01-AFC-4
CALIF ENERGY COMMISSION

May 7, 2001

Subject: East Altamont Energy Center Application for Certification
Data Adequacy Response Set 3

EAST ALTAMONT ENERGY CENTER DATA ADEQUACY RESPONSE SET 3

Table 3 -2005 HS Case with EAEC, **One Line** from EAEC to Westley Procter-Hurley Outage

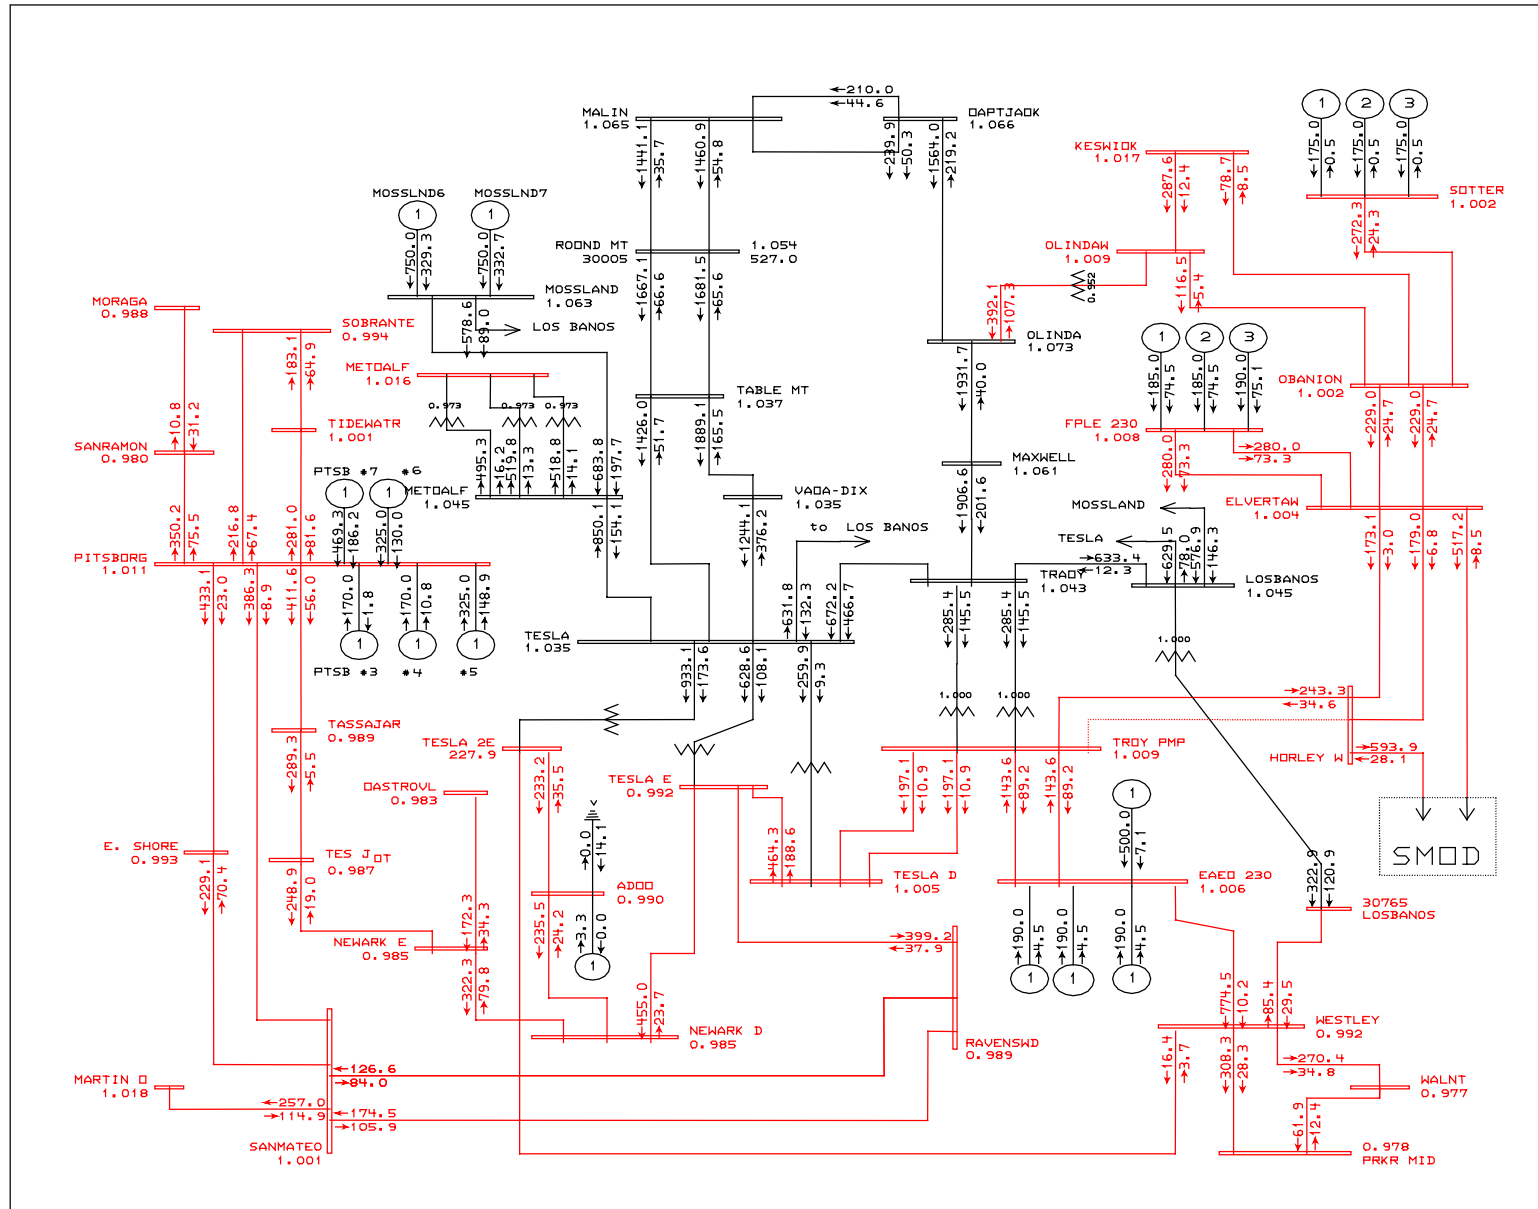
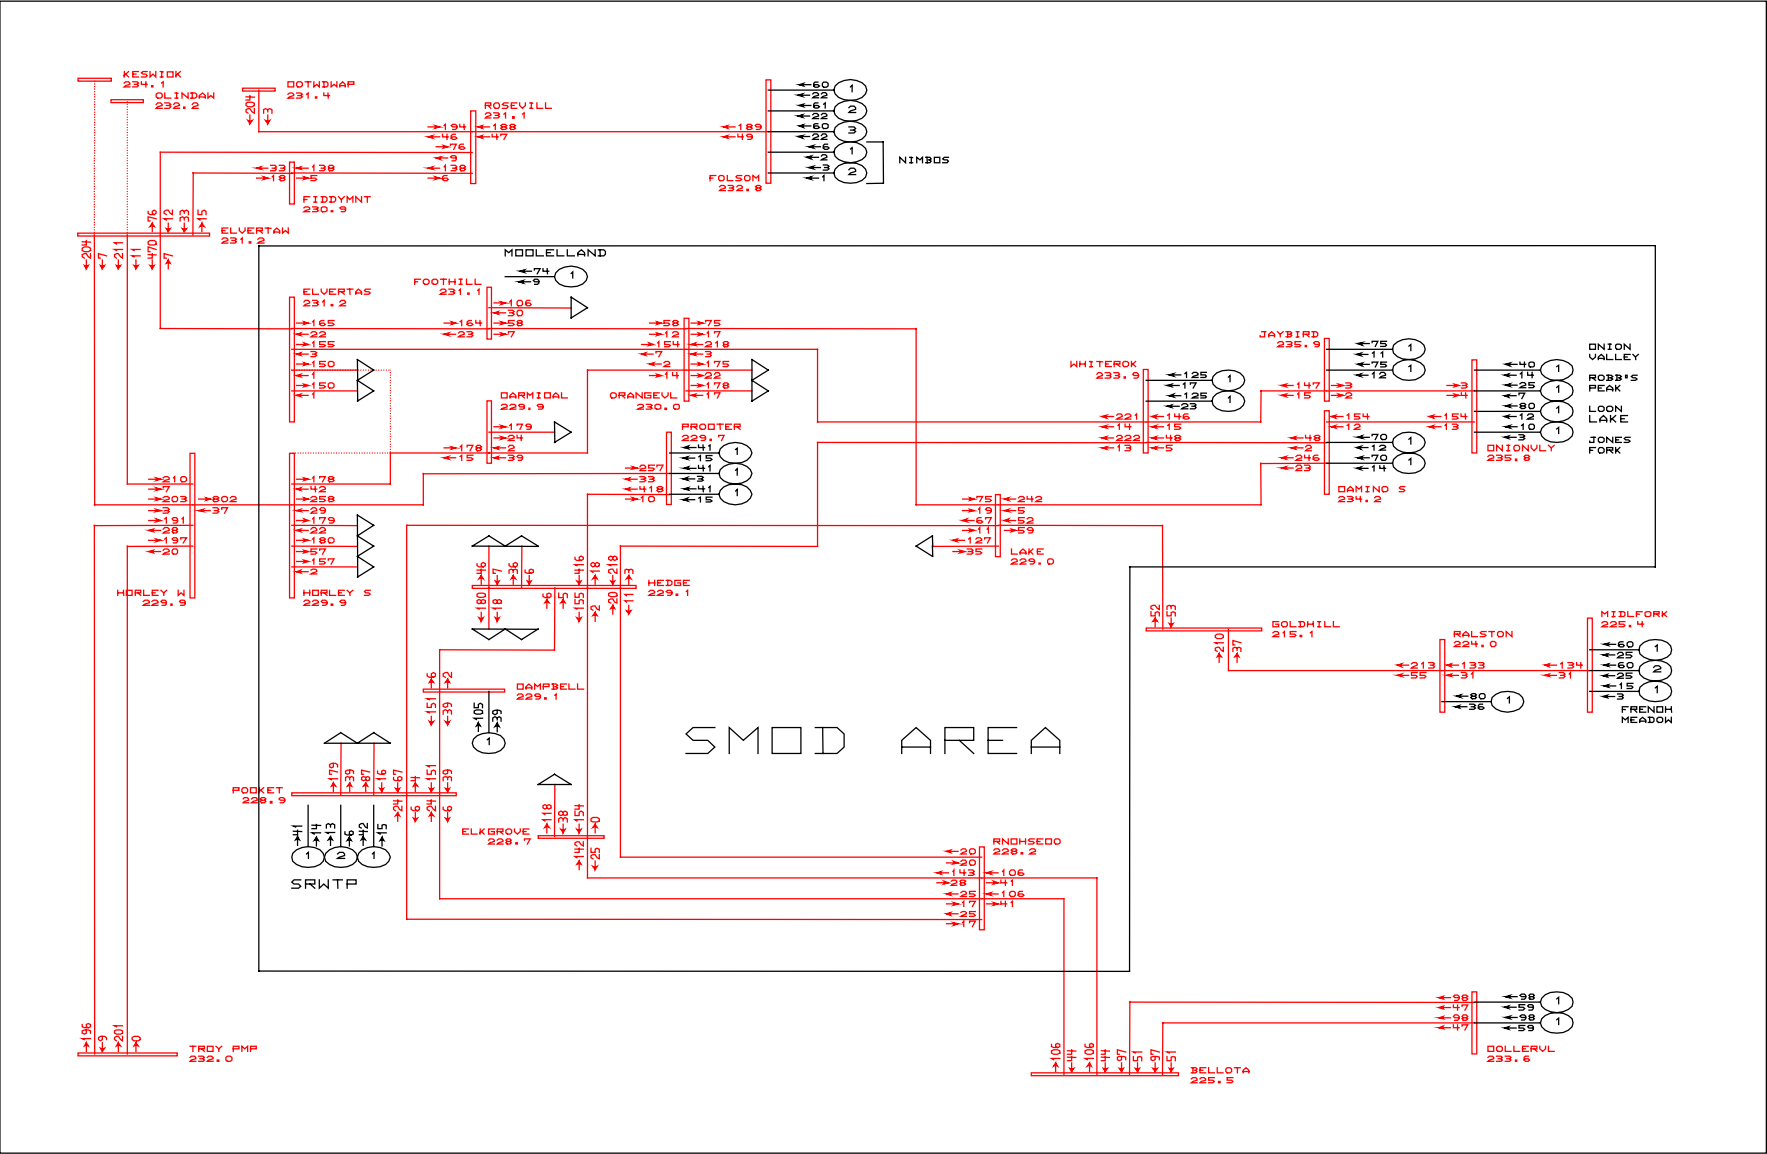
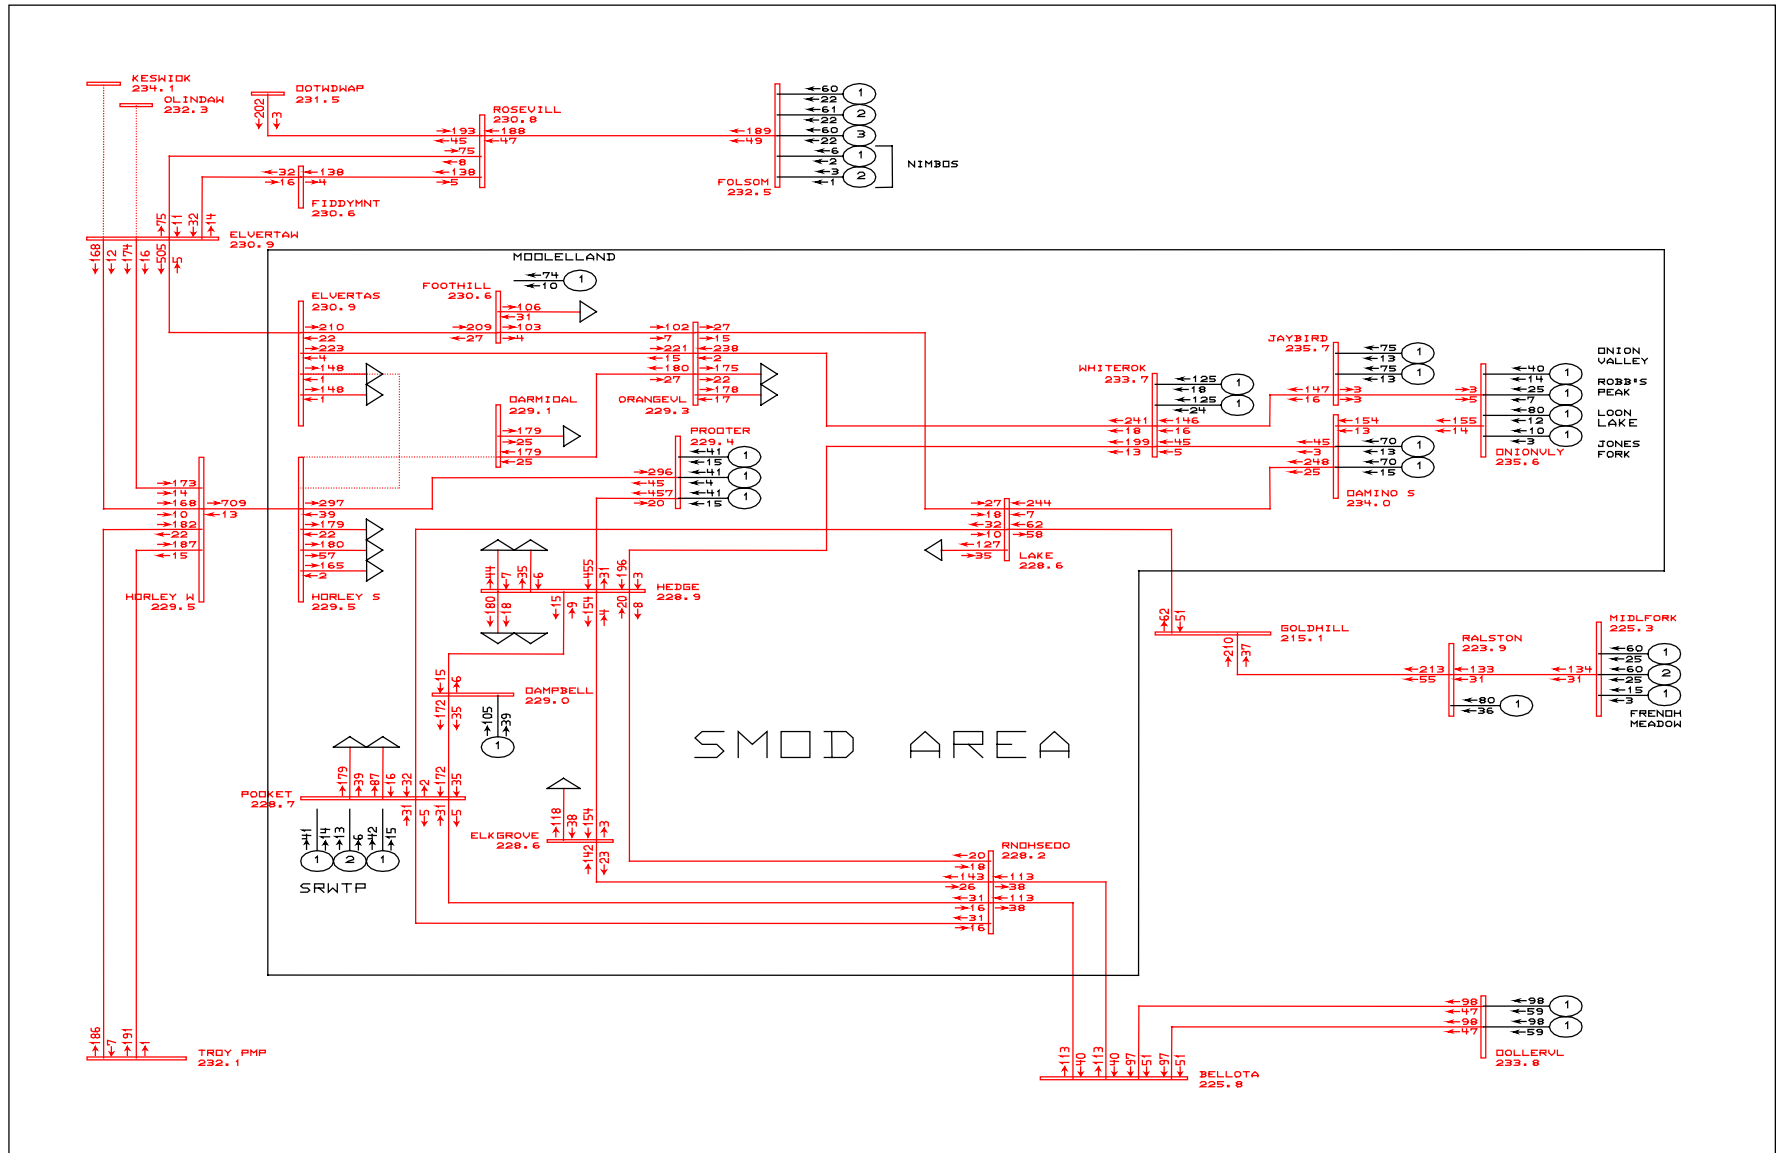
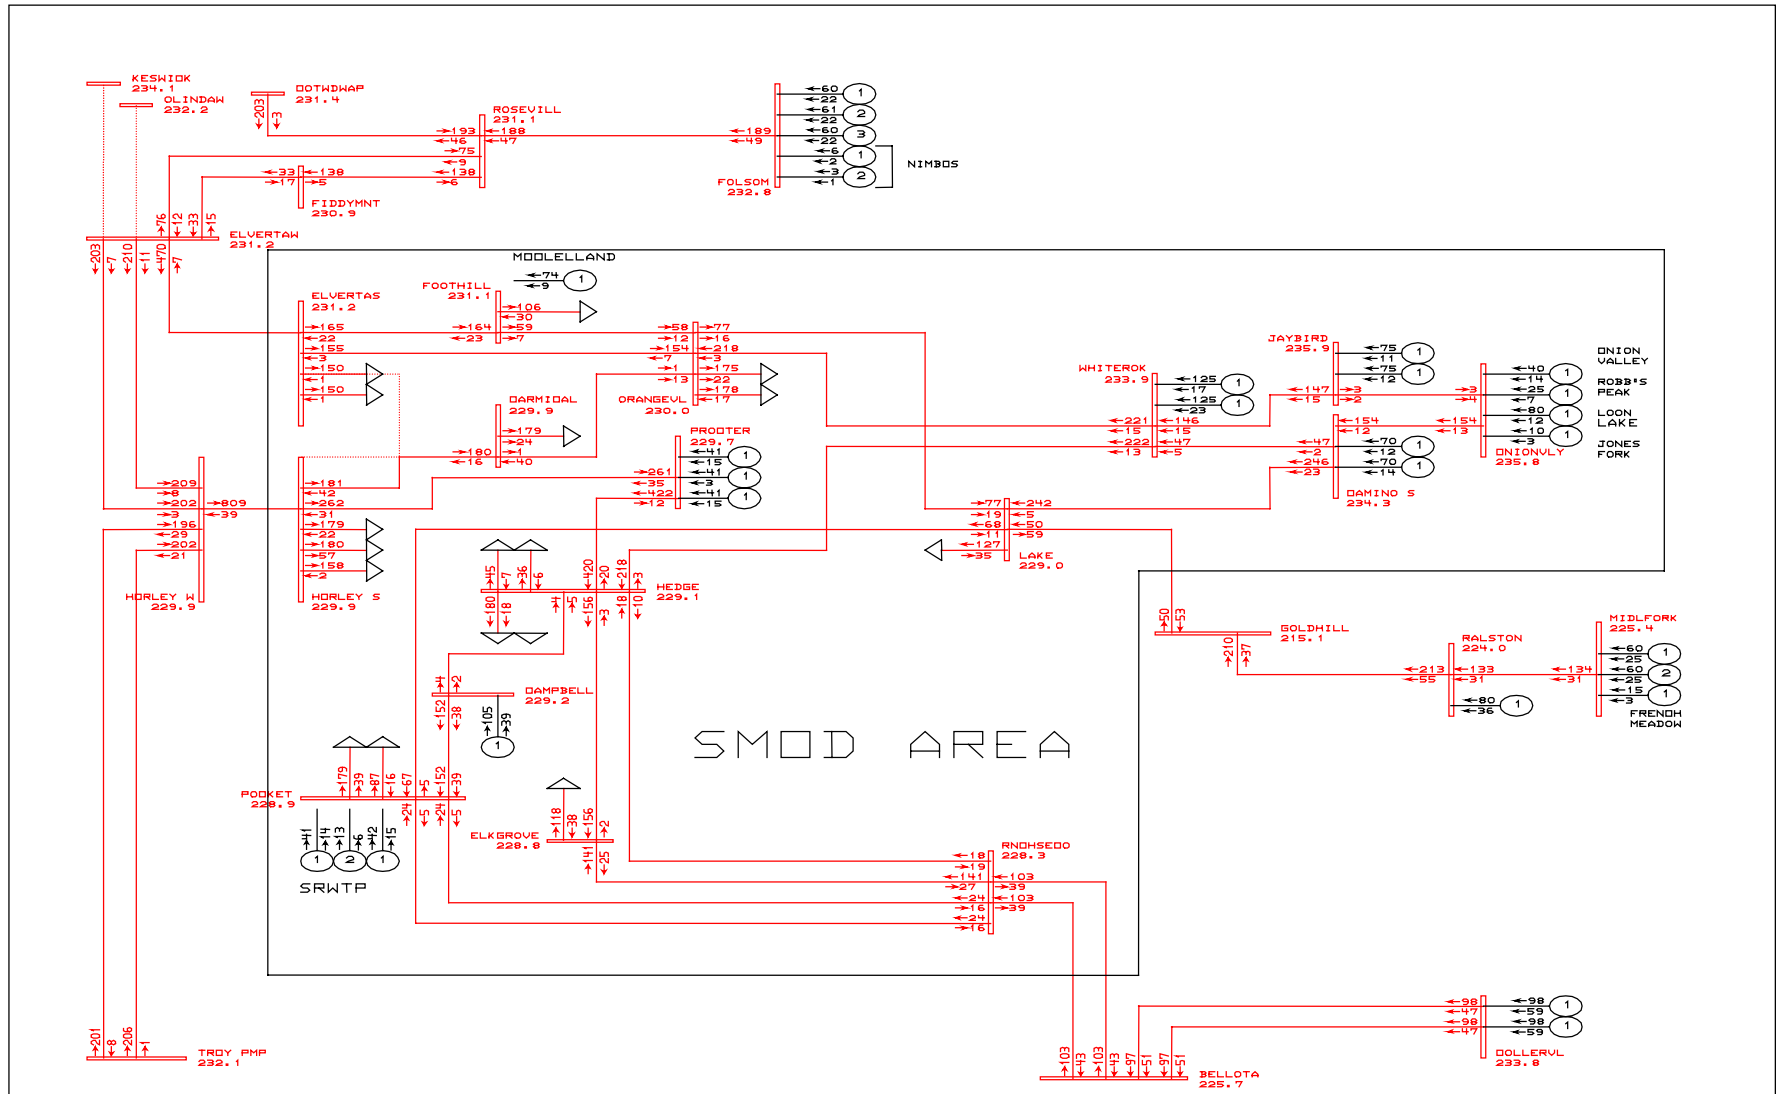
Data Adequacy Deficiency – Provide power load flow diagrams which demonstrate conformance or non conformance with utility reliability and planning criteria.

Provide a System Impact Study per the study plan of Appendix 5.4-A.

Data Adequacy Response – The power load flow diagrams prepared by Western Area Power Administration are attached as TSE-2. The attached power flow drawings are drawings of the base cases and the outages for each of the cases, which correspond to Tables 2, 3 and 4 in the System Impact Study submitted on May 2 in EAEC LLC's Data Adequacy Set 1.
